NUMBER: SB 500-21-009, Rev A
MODEL: ECLIPSE EA500
SUBJECT: Gearbox Venting Improvement

This Service Bulletin improves the performance of the gearbox venting on the GDCA.

This Service Bulletin removes the hose, vent cover, and vent valve to prevent oil leakage.

Figure 1. Parts Removal

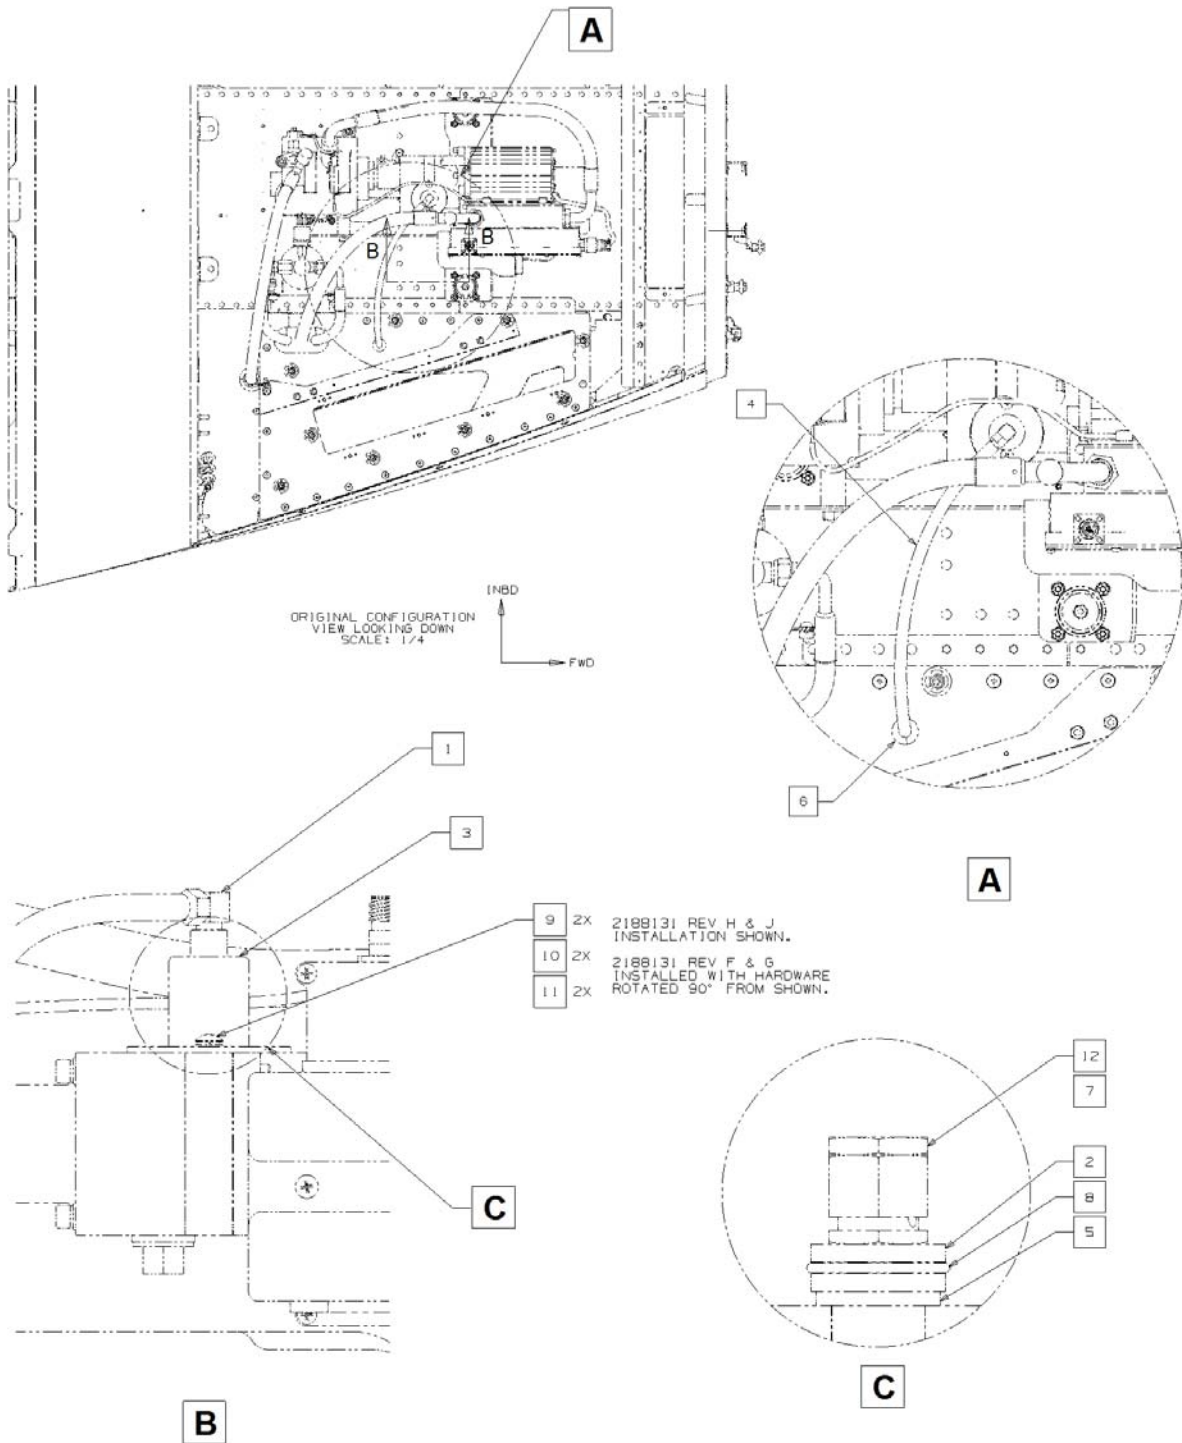
- (1) Clean off the sealant which held the tube to the grommet. Remove tube (2188515) and grommet (32-114432-2002), refer to [Figure 1](#).
- (2) Remove cover (2188279 or 2188281) with attached elbow (1ZJU4) and attaching hardware: screws (MS35206-242, X2), lock washers (MS35338-42, X2), and washers (NAS620C8L, X2), refer to [Figure 1](#).

- (3) From under the cover, remove the vent valve (YA-8024), o-ring (40-2556-G20), spacer (2188277), o-ring (MS28775-017), and gasket (2188527), refer to [Figure 1](#).

Figure 2. Parts Installation

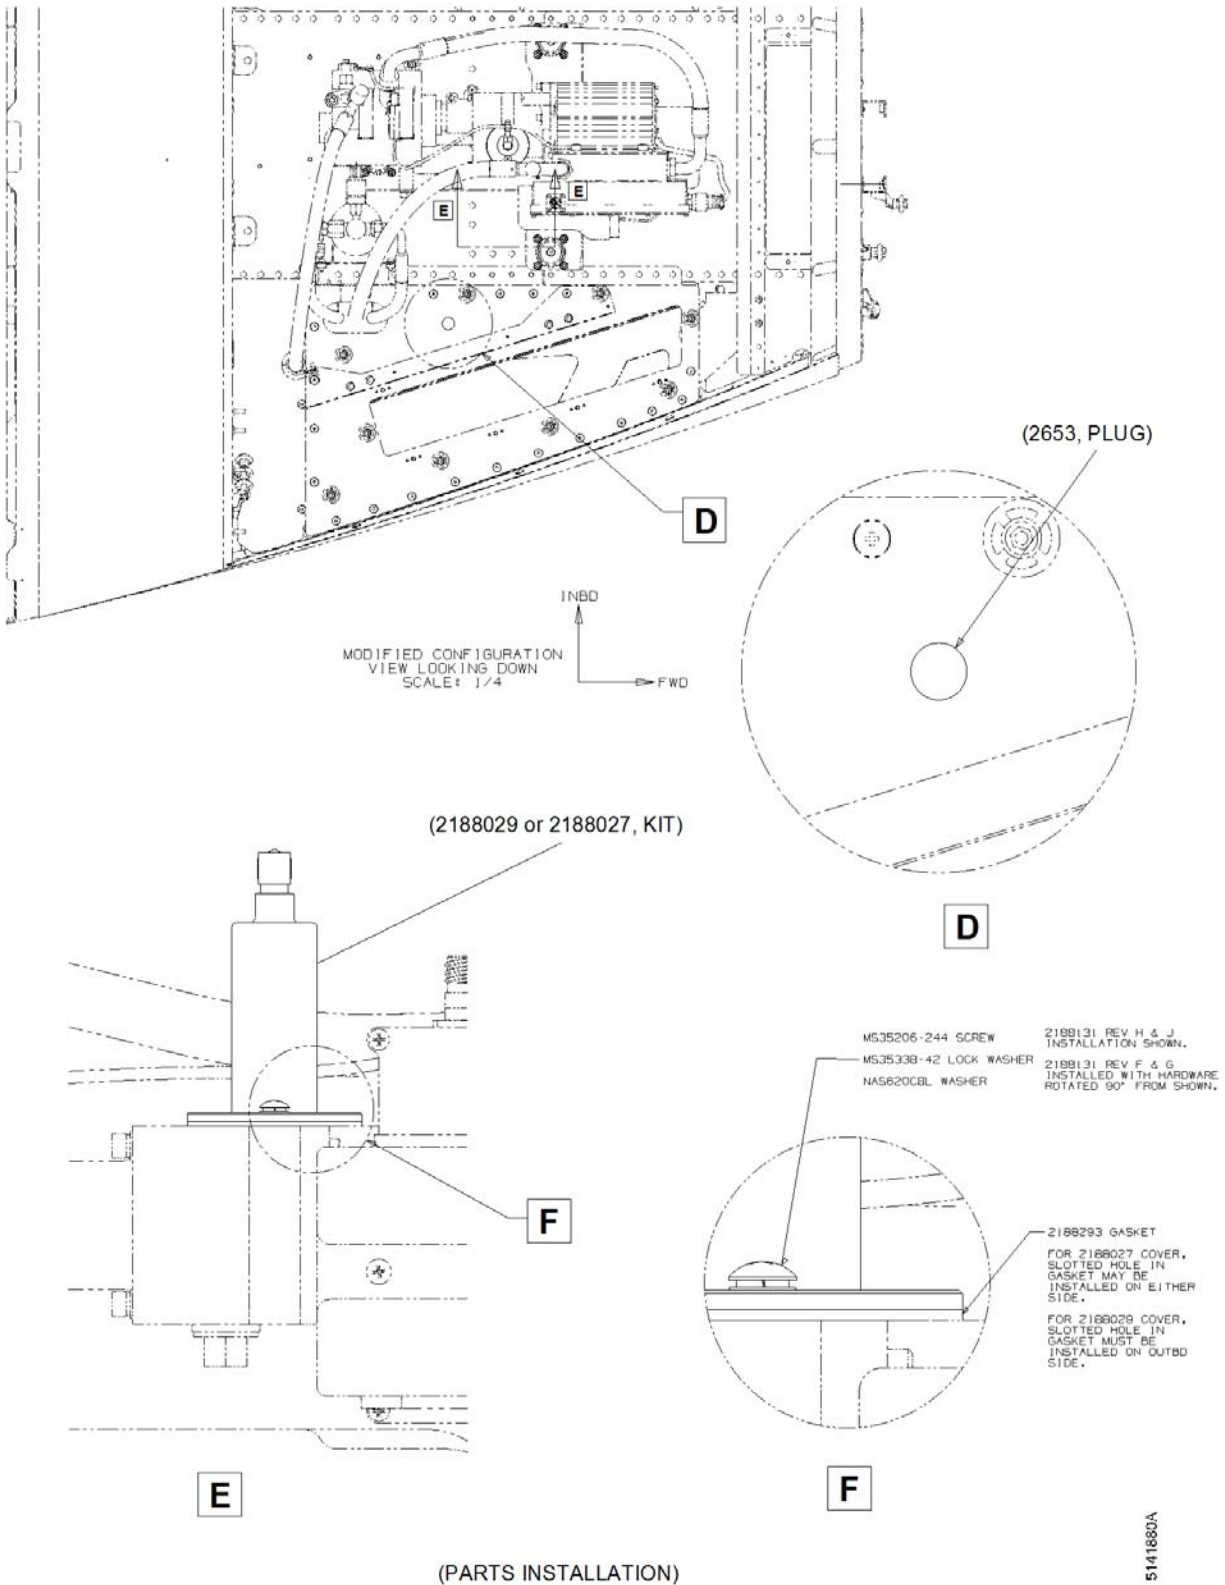
- (4) Clean up any oil found on top, bottom, or sides of the gearbox.
- (5) Install vent cover kit (2188027 or 2188029) with elbow installed, as shown, with gasket (2188293) and hardware as specified on [Figure 2](#), view "F". Apply Loctite 242 to screw thread and torque to 10–13in-lbs, refer to [Figure 2](#).

- (6) Install plug (2653) in existing grommet hole. Secure plug in hole by applying a fillet seal using RTV 106, refer to [Figure 2](#).
